V2500 Propulsion System — Nacelle

SERVICE BULLETIN

Subject: Transmittal of Revision 2 to Service Bulletin Number V2500-NAC-78-0085

NACELLE — EXHAUST — FLUID DRAINAGE, THRUST REVERSER —
MODIFICATION OF

Addition of Spacers to the Track Installation
Figure 1 (Sheet 1 of 2)

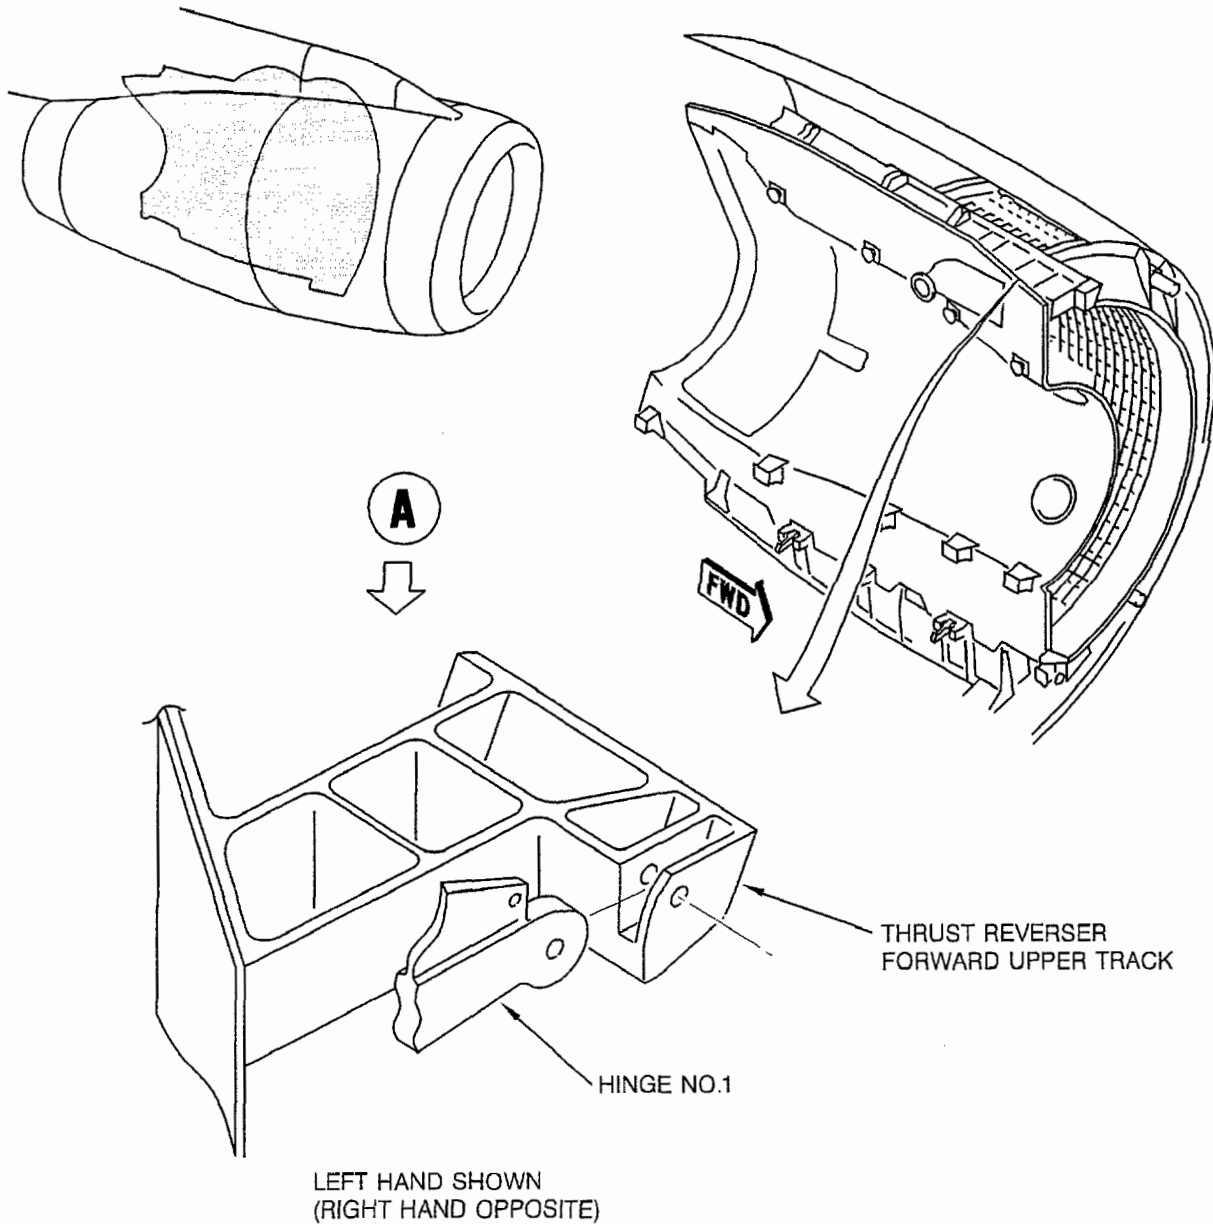
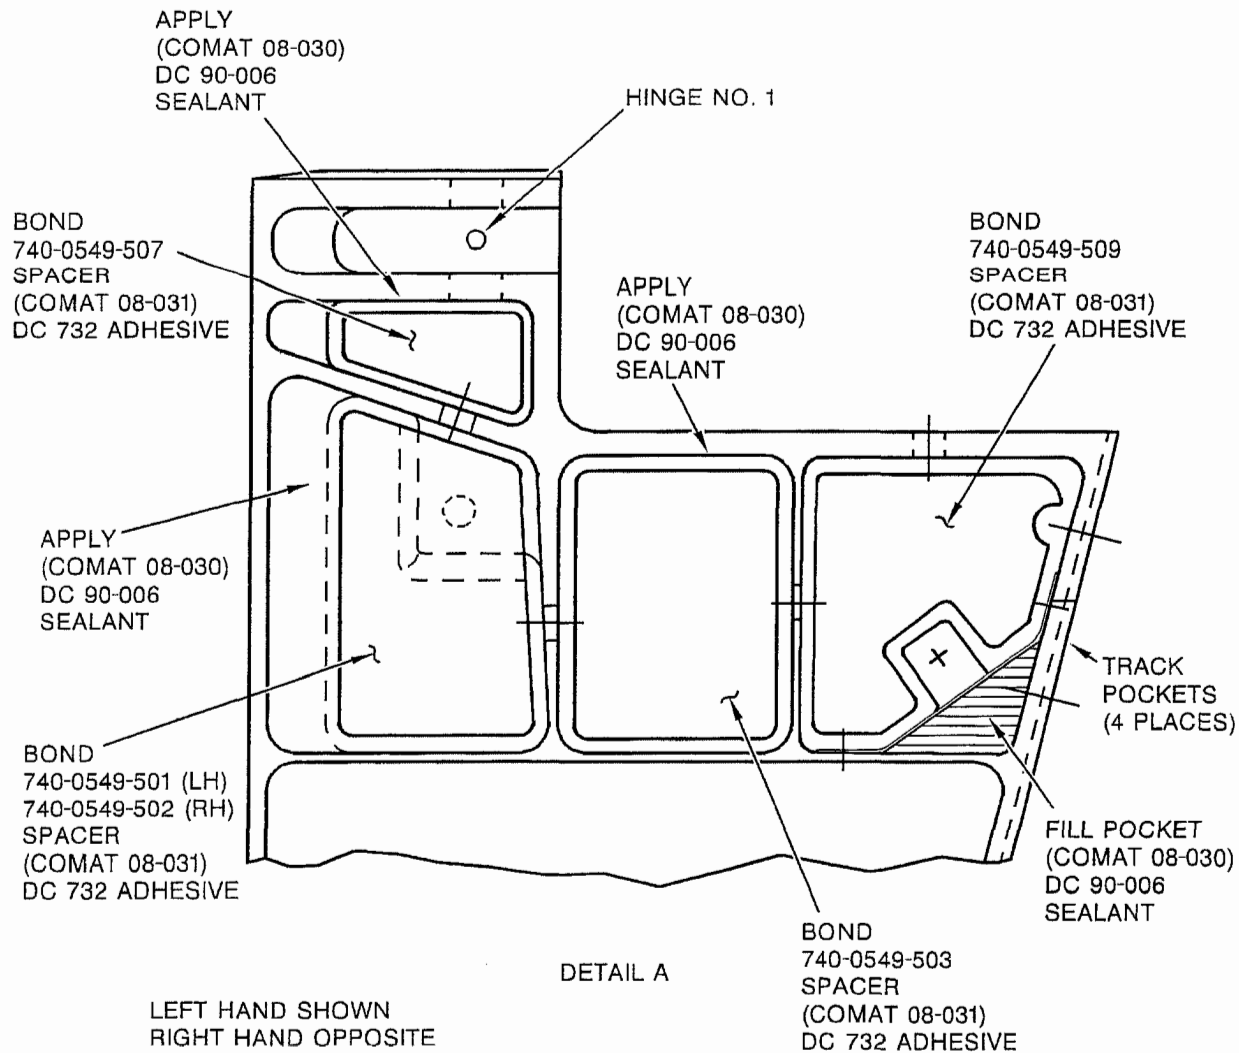
The change introduced by this Bulletin is to install spacers in track pockets on the fixed duct assembly, add drain holes to the lower skin panels, and seal holes and gaps that lead into the fan air duct.

- (1) Find the machined-out (track) pockets on the left hand thrust reverser forward upper track area aft of hinge number 1. Refer to Figure 1.

- (9) Put each 740-0549 spacer in the position shown in Figure 1. Apply sufficient pressure to keep spacer in touch with mating surface without causing too much adhesive leakage.
- (10) Allow to dry for a minimum of 8 hours.

Addition of Drain Holes and Sealing of Gaps and Holes
in the Lower Track Installation

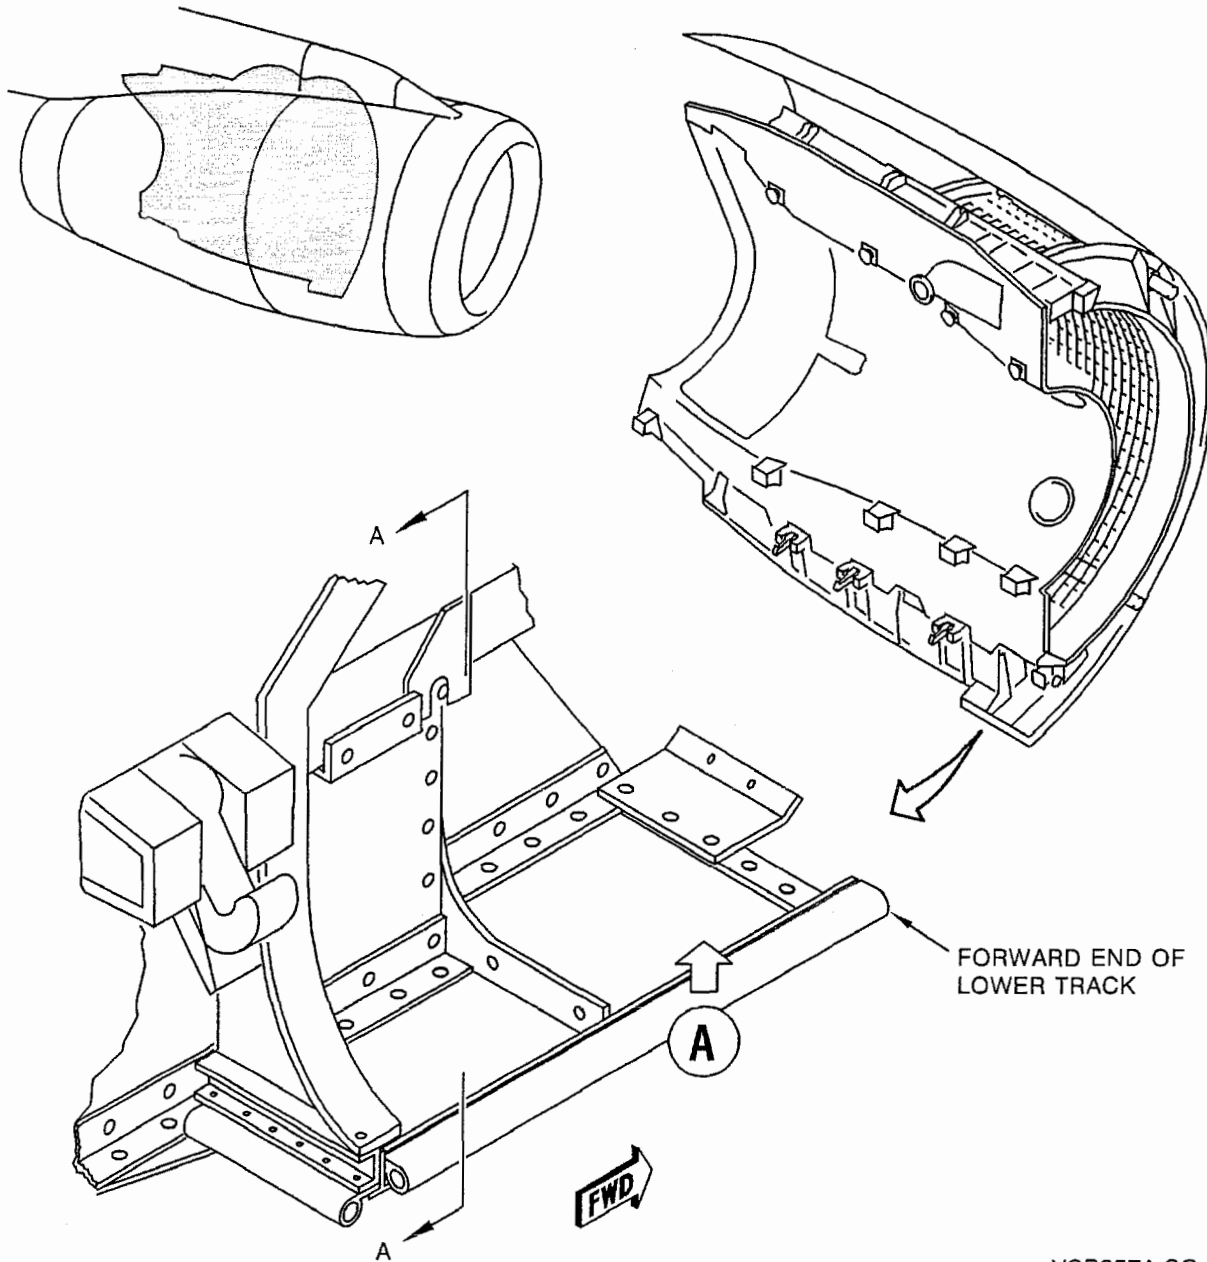
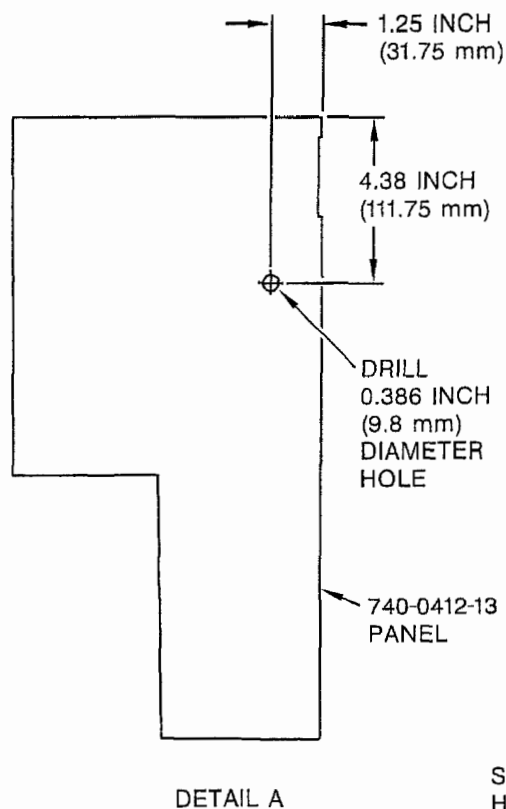
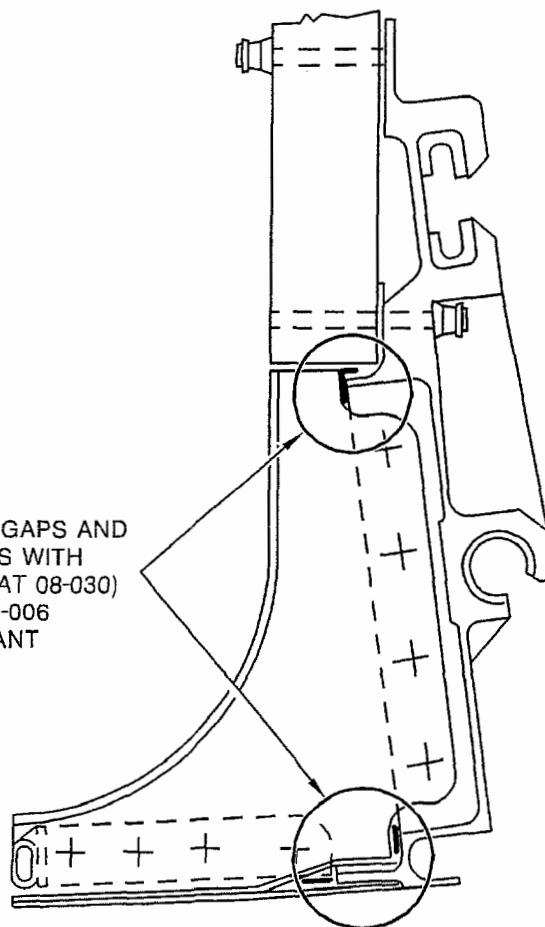
- (11) Refer to manufacturer's instructions to mix sealant (CoMat 08-030). Apply sealant around the spacers. Fill all clearances and stop as many air bubbles as possible.
- (12) Do steps 2.A.3 through 2.A.12 for the right hand thrust reverser door.
- (13) Find and make a mark for the drain hole positions on the lower track panels. Refer to Figure 2.
- (14) Drill a 0.386 inch (9.8 mm) hole with a letter W drill in each panel. Burr holes.

SEAL GAPS AND
HOLES WITH
(COMAT 08-030)
DC 90-006
SEALANT

- (15) Apply conversion coating (CoMat 07-028) to the holes with a nylon brush or cheesecloth. Keep surface wet with fresh solution for 2 to 5 minutes.
- (16) Inspect the entire lower track for gaps or holes and all pandowns for correct sealing. Refer to Figure 2.
- (17) Use a lint free (CoMat 02-099) cloth and MEK (CoMat 01-076) to clean any areas of the assembly (holes or gaps) to be sealed. Wipe surface dry before solution becomes dry.
- (18) Refer to manufacturer's instructions to mix sealant (CoMat 08-032). Apply sealant in the clearances or holes as necessary. Fill all clearances and stop as many air bubbles as possible.

FAMILY TREE-
NO. 1 POSITION THRUST REVERSER
LEFT HAND SIDE
REF: CATALOG SEQUENCE NO. 78-30-00 FIG. 01, ITEM 130

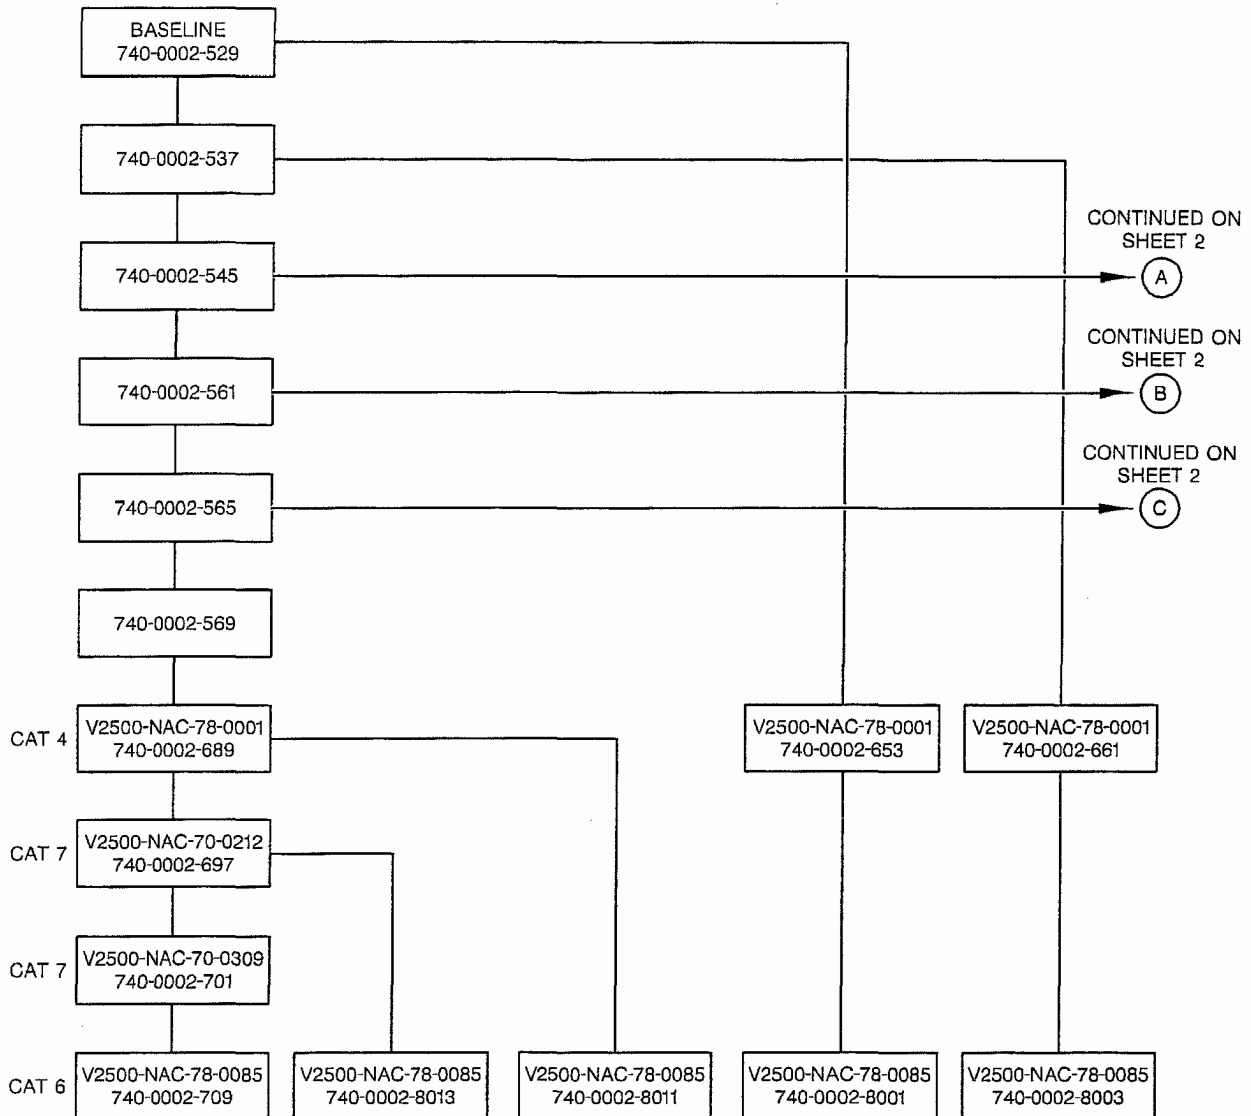
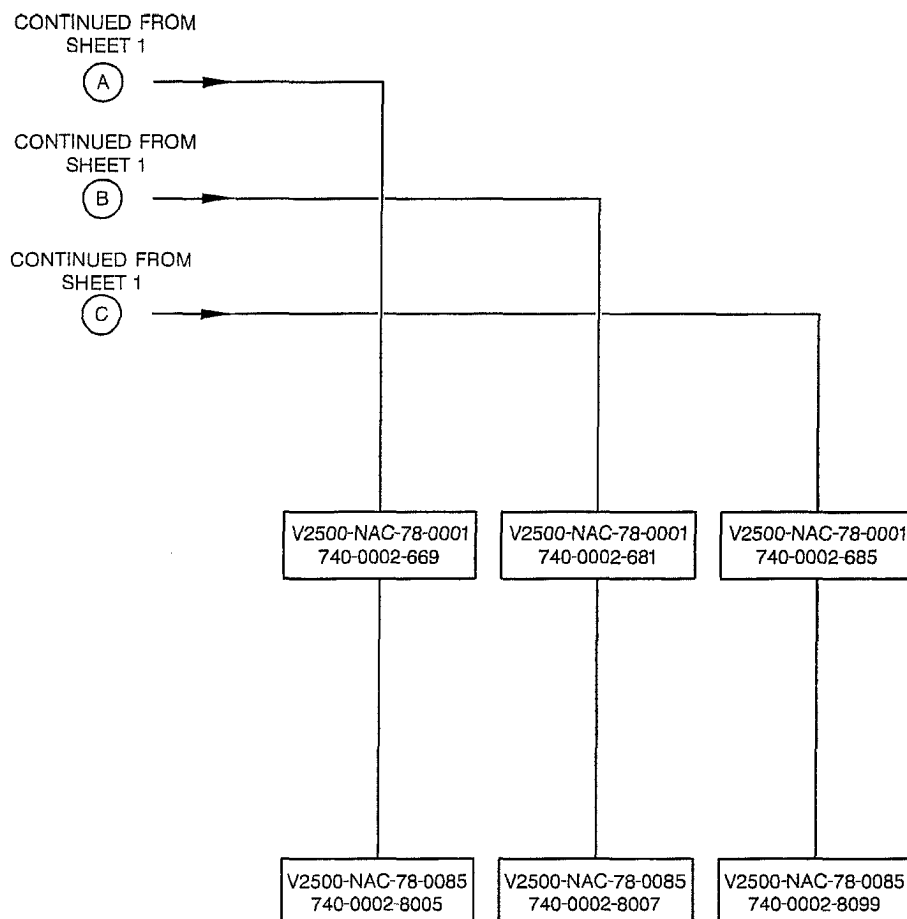
- (1) To instruct removal of the 740-0002-8000 series part numbers and re-identification to the original part number because the '8000' series part numbers are not traceable in the manufacturer's engineering system.
- (2) To revise the text of the service bulletin to remove references to 740-0002-8000 series part numbers.

For thrust reverser which have been previously re-identified as a 740-0002-8000 series part number, re-identify these thrust reversers to their original part number. Refer to Figures 3, 4, and 5 if you need help to determine the original part number.

740-0002-701 as 740-0002-709
740-0002-693 as 740-0002-705
740-0002-703 as 740-0002-711
740-0002-695 as 740-0002-707
